Permit Number: 081249

**Subject: Plan Review for Permit # 08-1249 – 2nd memo
158 Grant St. CBL: 053 C010001**

**Subject: Plan Review for Permit # 08-1249
158 Grant St. CBL: 053 C010001**

RATED WALL ASSEMBLY DETAILS FOR 158 GRANT STREET-

CLIENT	158 GRANT STREET PORTLAND, MAINE		
	RECONFIGURED FLOOR PLAN 4 UNIT CONVERSION		
DRAWN BY:	SMS	SCALE:	AS NOTED
		PAGE:	07-30-04
DRAWING NUMBER	A-1		REV.

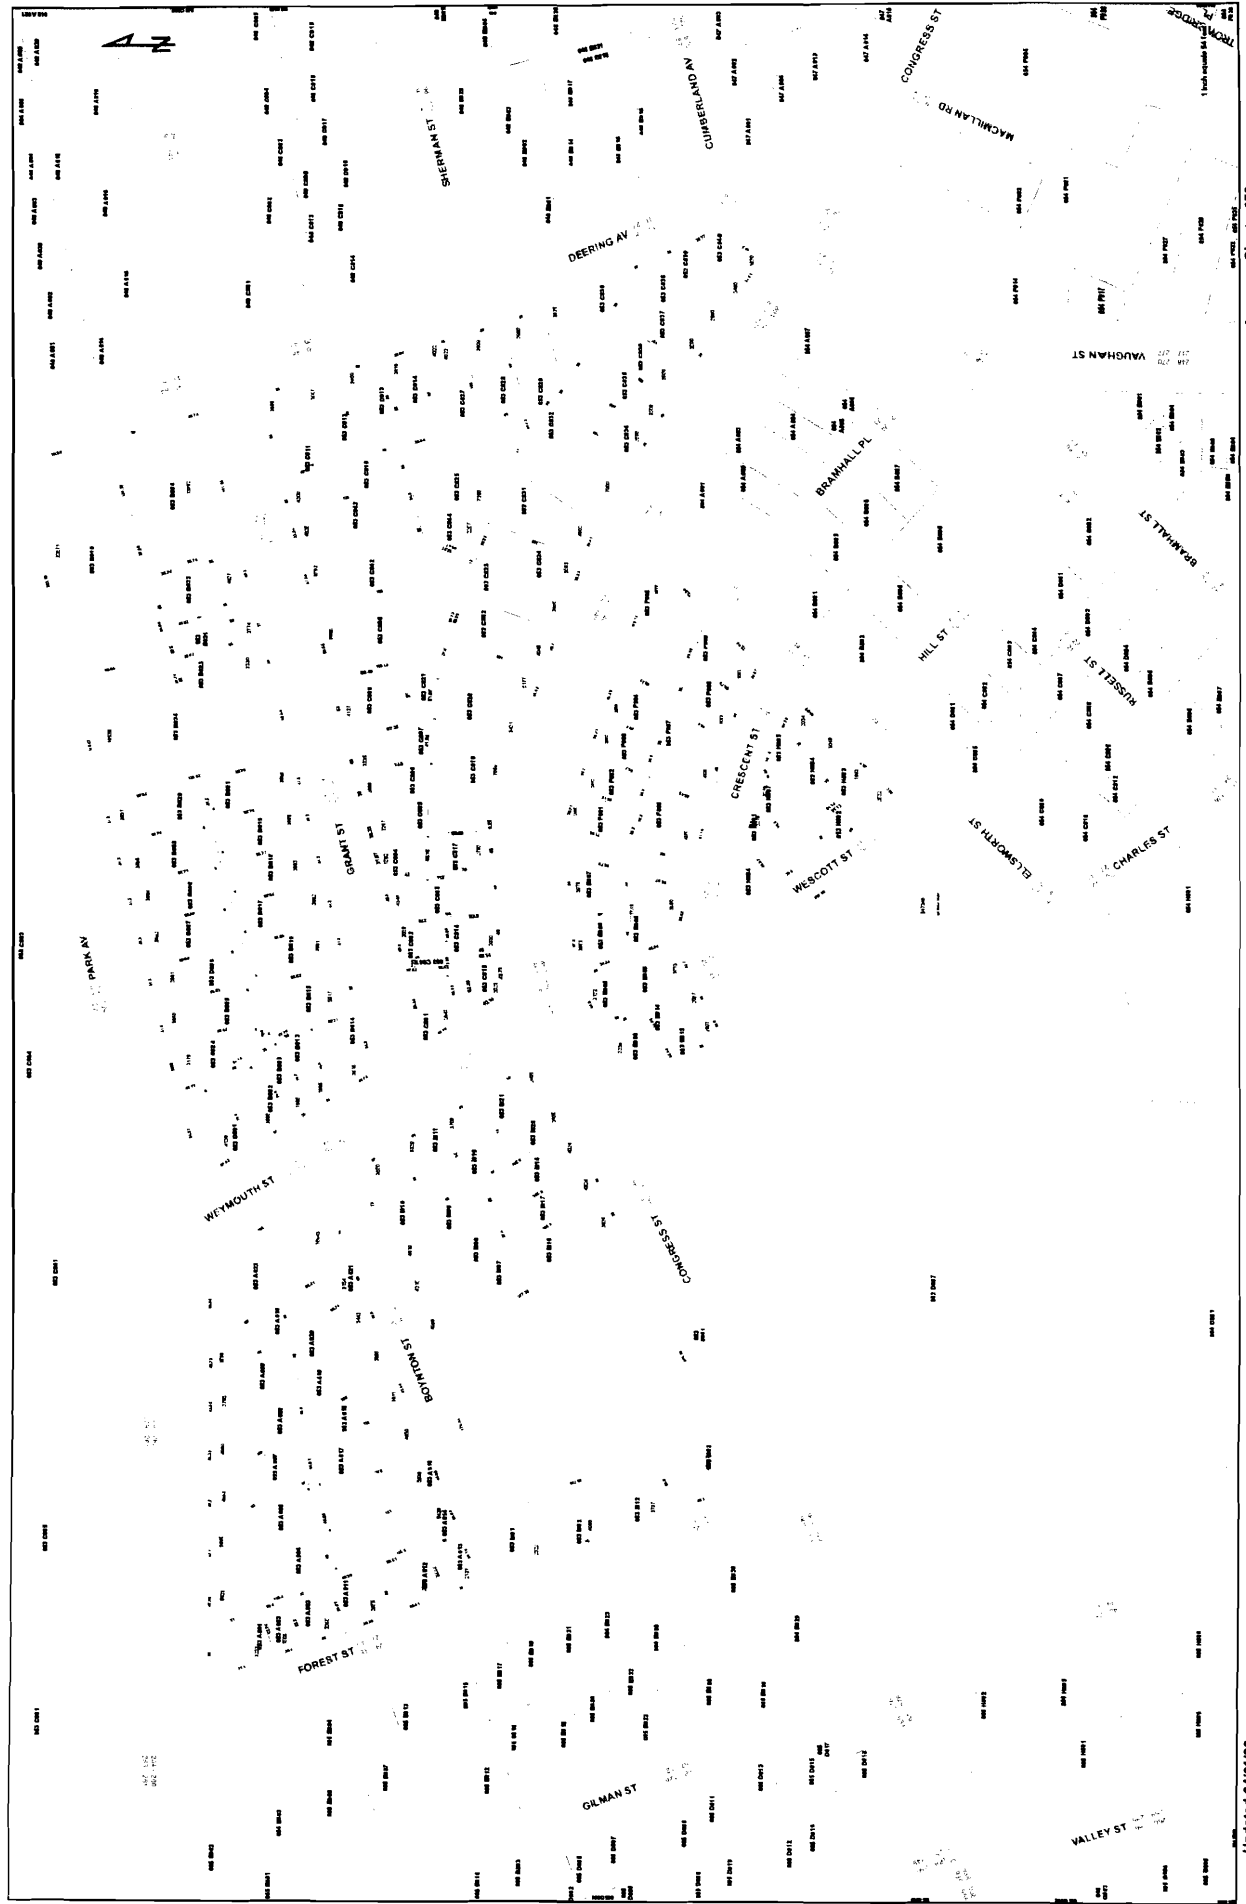
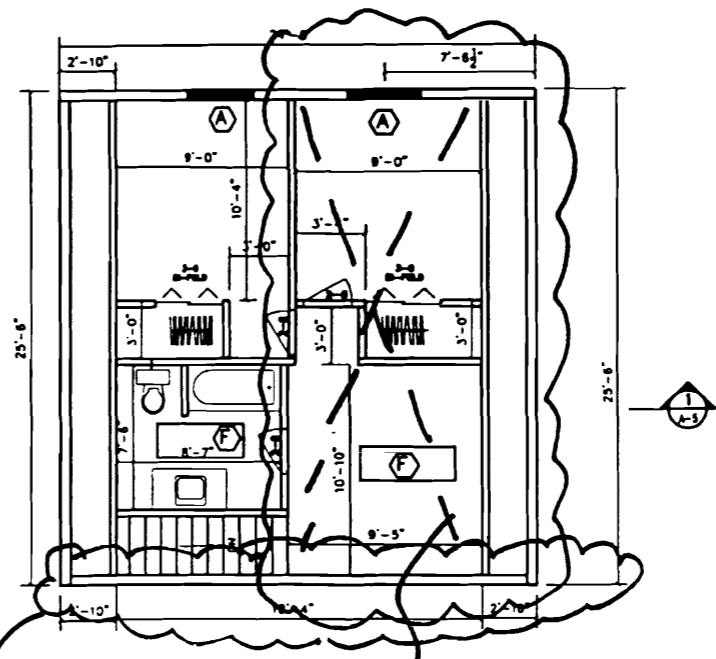
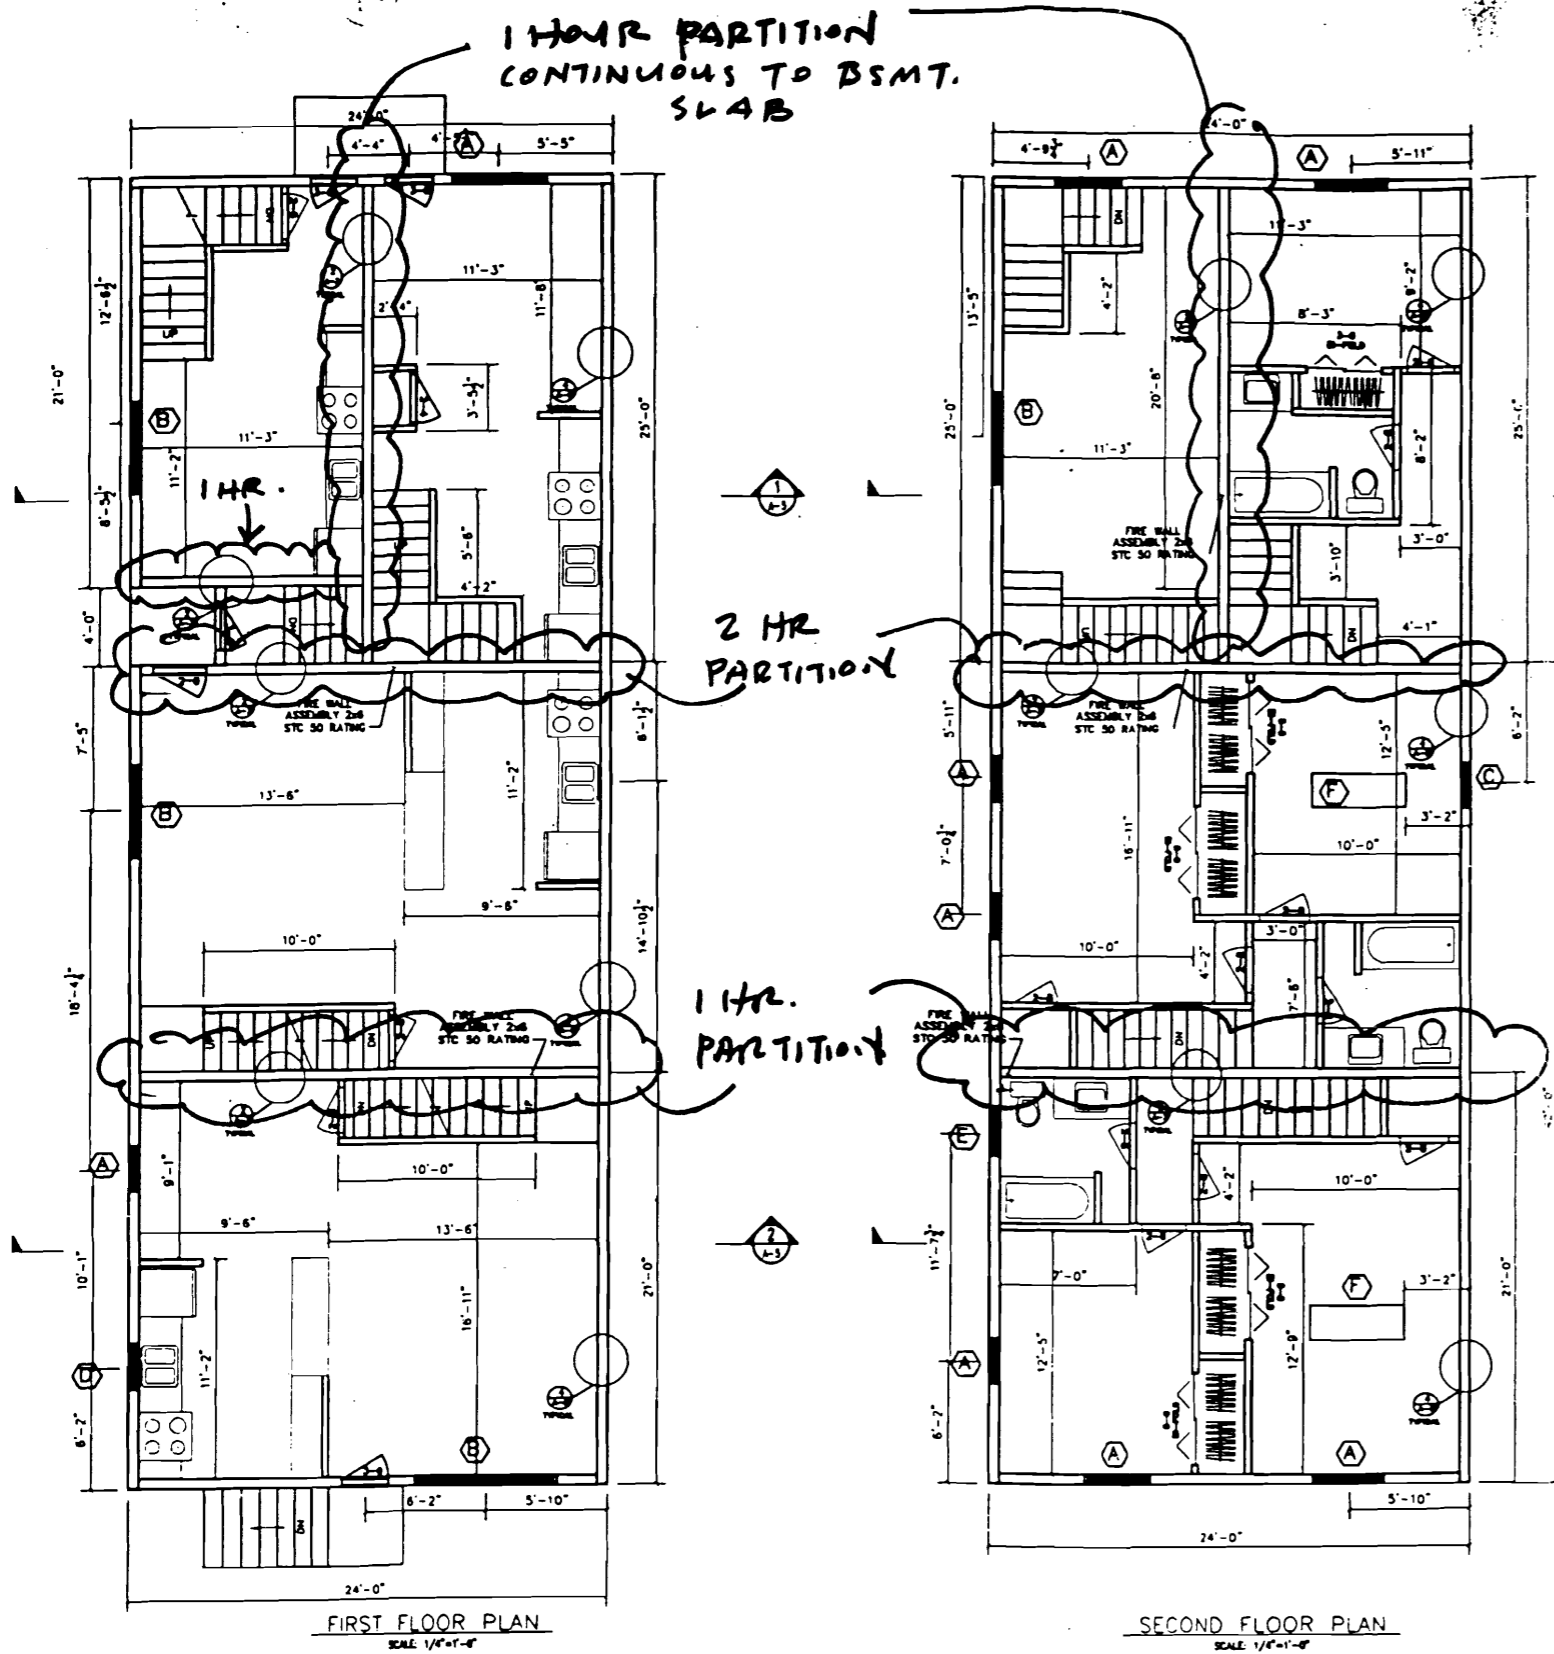
Looks like the floor-ceiling system should have been listed as UL Design L505 (not L522). Also, on the page listed as Drawing Number A-6, it does show a Rating/Design for the fiber cement siding used.

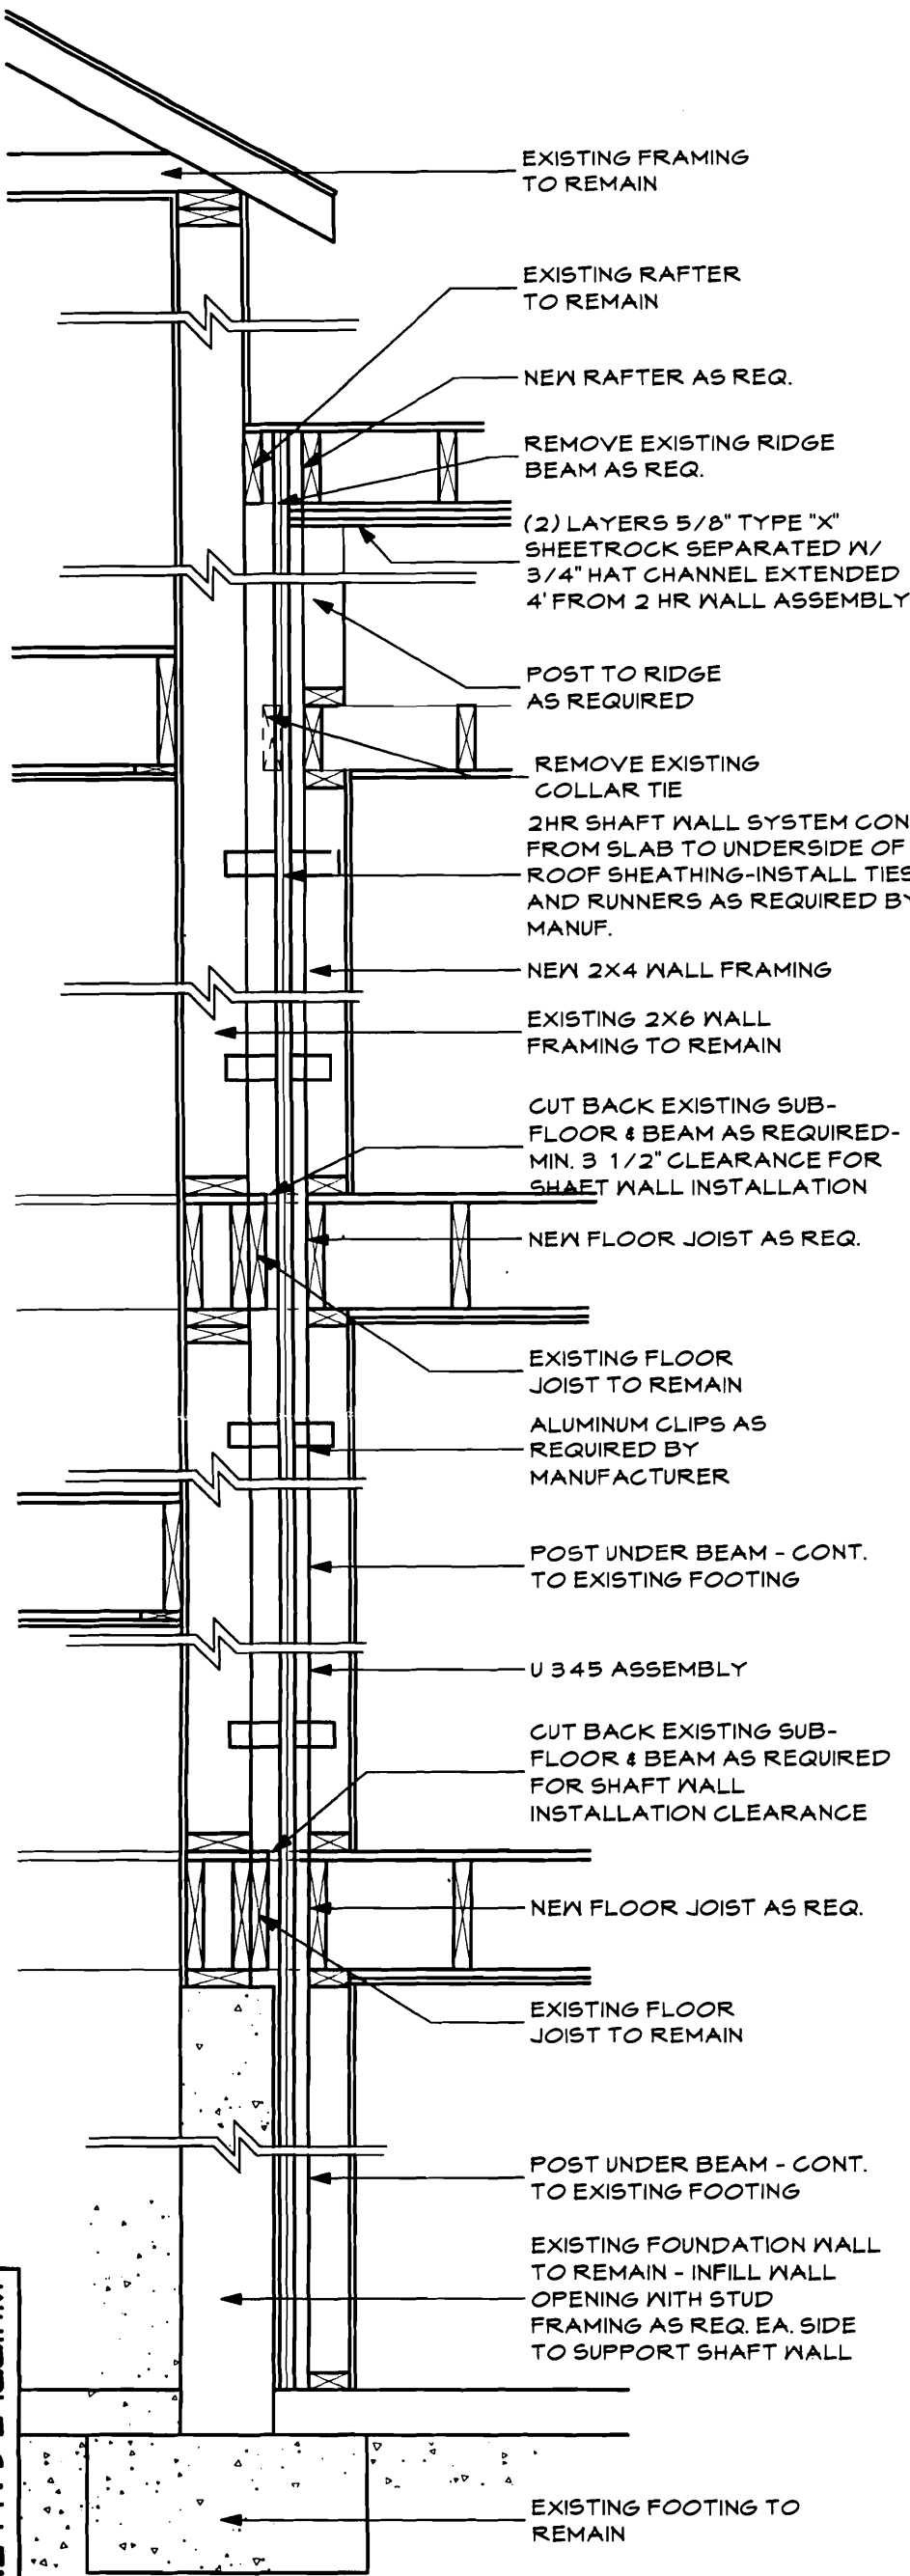
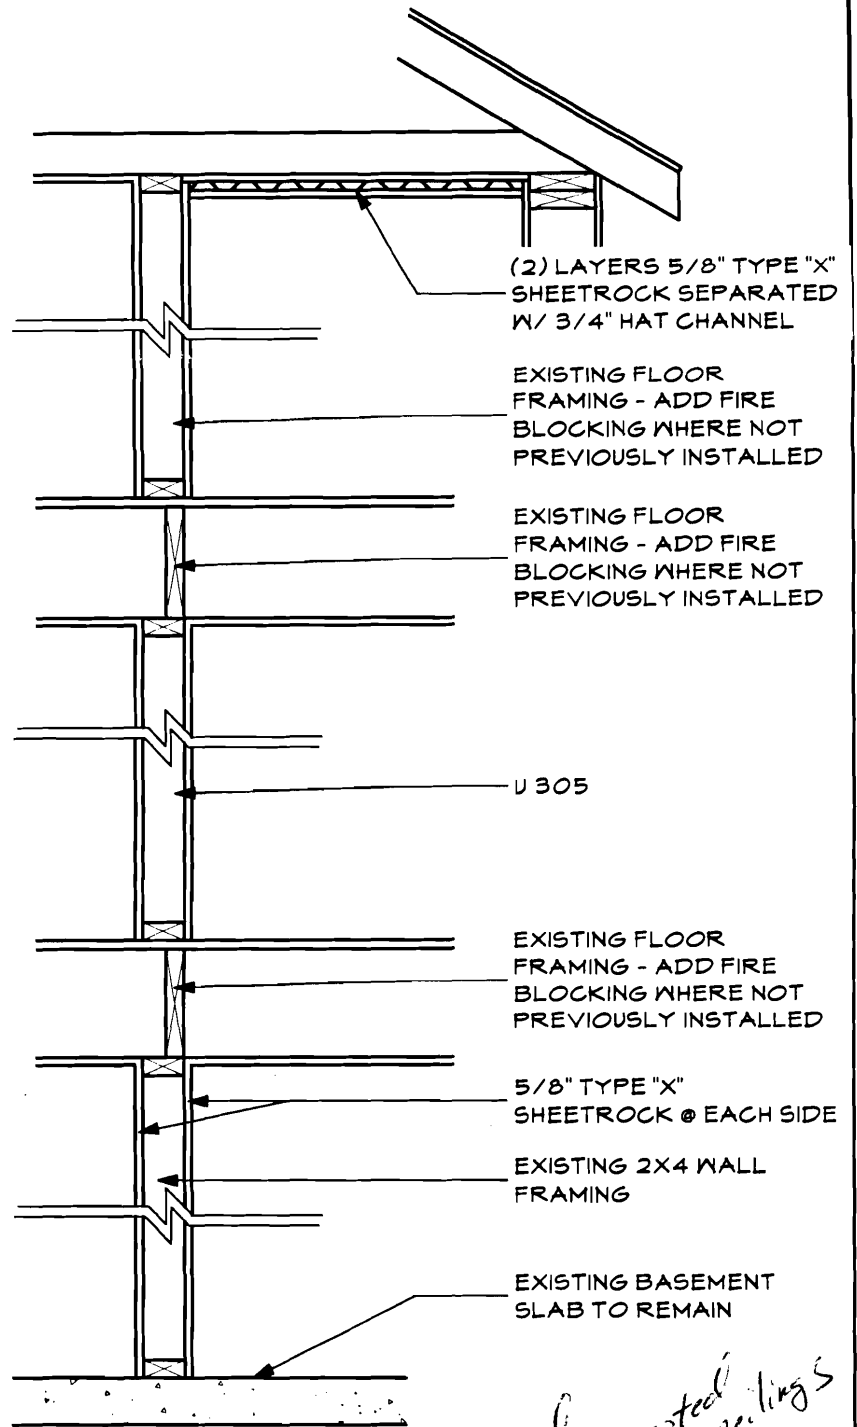
Need 5/8 noted on ceilings
